Draft decision
Directlink transmission determination
2015-16 to 2019-20
Attachment 6: Capital expenditure

November 2014

AER reference: 53446

Figure 6-1 Directlink—actual and proposed capex (\$ million 2014-15)

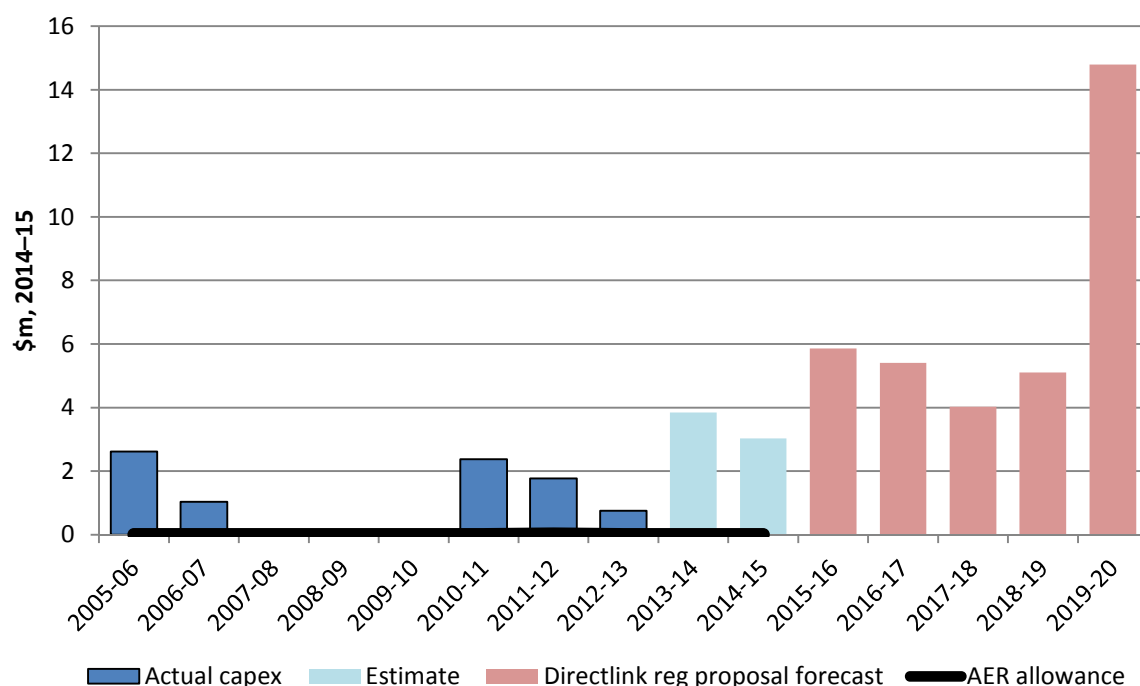
Figure 6-1 shows the increase between Directlink's proposed capex (2015-20) and its historic capex (2005-15). The principle increase in Directlink's proposed capex is attributed by Directlink to increases in expenditure to reliability to ensure availability of the link at maximum capability. Directlink stated that its forecasts for the capital projects in the refurbishment (or "stay-in-business"¹¹) and compliance categories reflect the impact of the Mullumbimby converter station fire in August 2012 to the Asset Management Plan approved by Directlink's Board in November 2013.¹²

Figure 6-2 Directlink capital expenditure (\$ real June 2015)

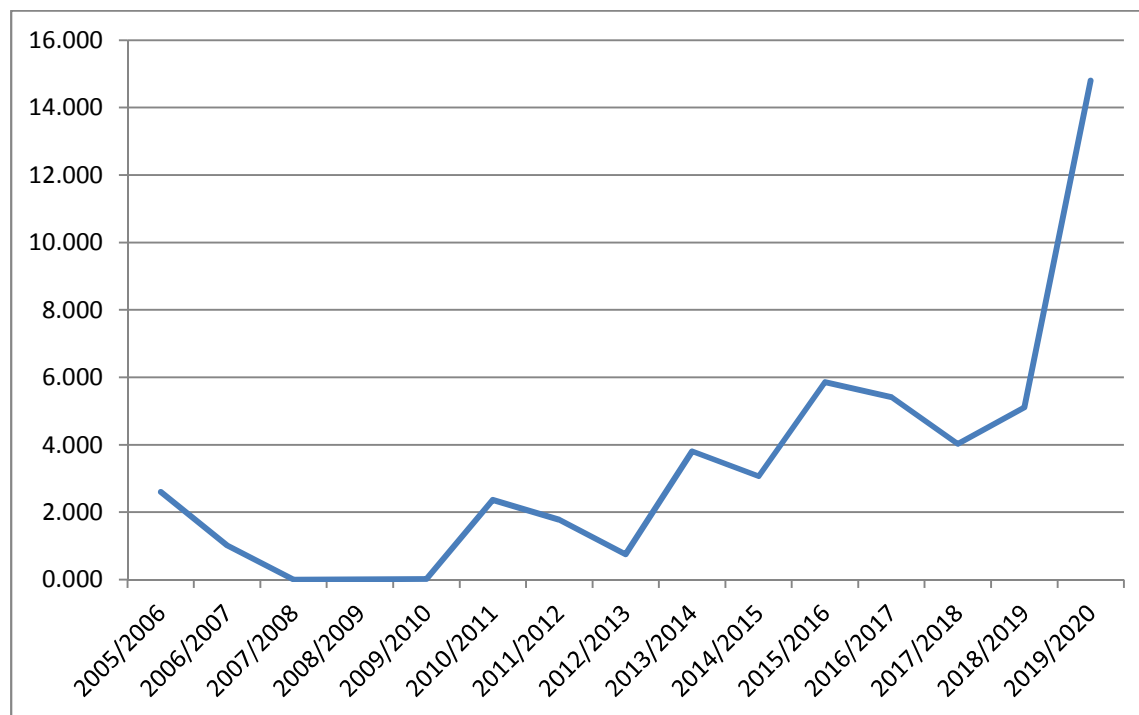
regulatory control periods.²⁹ Directlink's capex proposal in this context suggests that the proposal appears relatively high when compared with the historic trend (see Figure 6-2).

For the period up to 2014/15, Figure 6-2 shows actual/estimated historic capex (rather than forecasts and allowances). Directlink submitted that the proposed capex program reflects that a number of its assets are nearing the end of their useful life as well as the requirement to maintain the maximum capability of the link with a high degree of reliability, whilst ensuring that all regulatory, statutory and legislative requirements are met. We reviewed this justification in the course of assessing the capex program proposed by Directlink's capex forecasts as discussed in section 6.4.2.
